APPENDIX 2.4
LBH EIA SCOPING OPINION

Scoping Opinion

Site Location:	Homebase, Syon Lane, TW7 5QE
Development proposal:	Demolition of the existing buildings, and the construction of a residential led mixed-use development comprising multi-storey buildings, the tallest buildings up to a maximum height of 16 storeys (75m AOD) providing up to 500 residential units, up to 10,700 sqm (gross internal area) of commercial floorspace (Tesco Extra) and flexible commercial use, with car parking
Scoping Application Ref:	00505/H/SCOPE1
Ward:	Osterley and Spring Grove

Figure 1: TfL - Modelling and Survey Scope

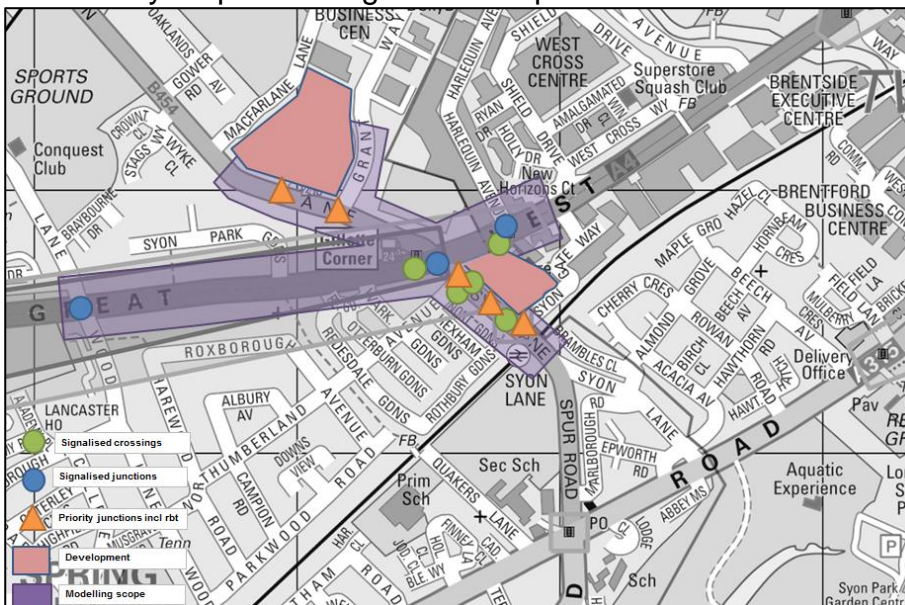
- Syon Lane / Grant Way (Rbt)
- Syon Lane/ Tesco access (Rbt)
- 25/013 & 25/287 - Syon Lane / A4 Great Western Road (Signalised)
- Harlequin Avenue / A4 Great Western Road (Signalised)
- Syon Lane/ Northumberland Avenue (Priority)
- Syon Lane/ Homebase access (Priority)
- Syon Lane/ Syon Lane Gateway (Priority)
- 25/156 & 25/157 – Syon Lane / Northumberland (Signalised Crossings)
- 25/301 - Syon Lane Station (Signalised Crossing)
- 25/014 - Syon Lane / Wood Lane (Signalised)

The inclusion Wood Lane junction will allow replicating A4 arrival patterns from west – this is likely to be modelled through coding in current signal operation and at this stage it isn't envisaged that MCC counts would be needed as well.

AM Peak Delays (2018)

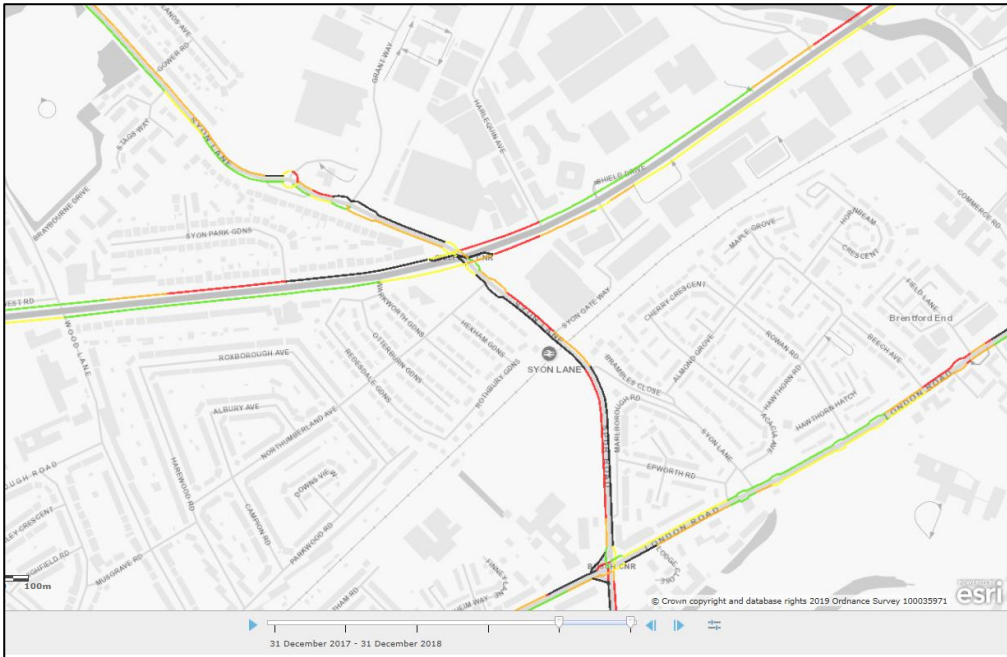
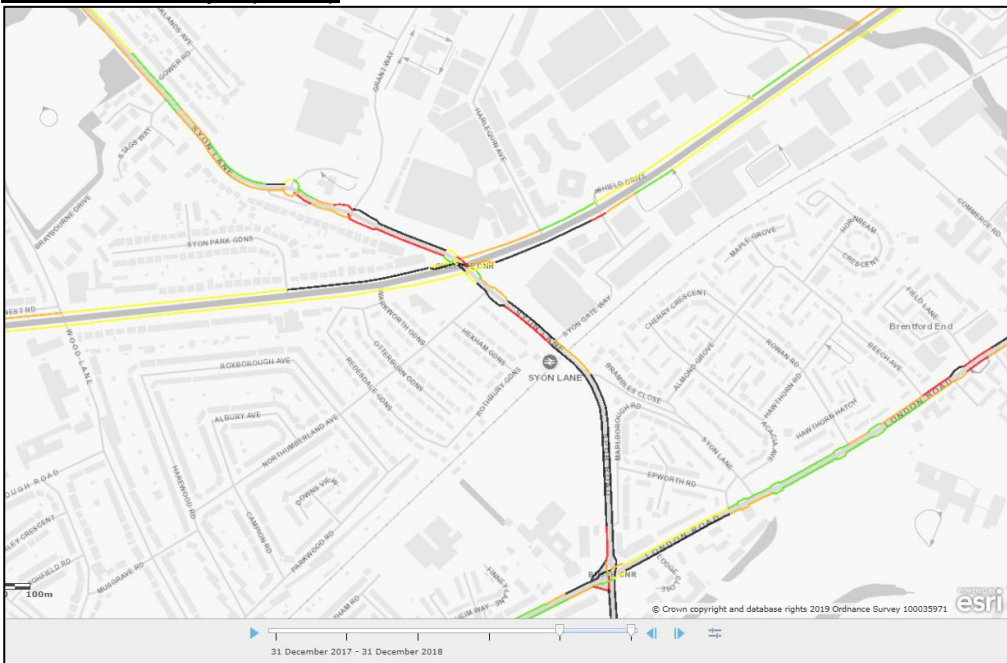
The map below shows the level of network resilience in both AM and PM peaks with black marks showing delays over 1.5 min/km.

The consultant's proposal to use LinSig and PICADY models of Gillette Corner and access junctions. As discussed during the pre app meeting this may not be appropriate due to significant level of friction from multi directional highway interaction (give way in junctions

in proximity of two signalised stop lines, queueing back through priority controlled junctions (Syon Lane / Grant Way) and complex driving behaviour (three lanes of opposing signal controlled operation). Instead it is expected that accurate reflection on current and proposed operation is likely to be captured in a more robust way if carrying the assessment using microsimulation models.
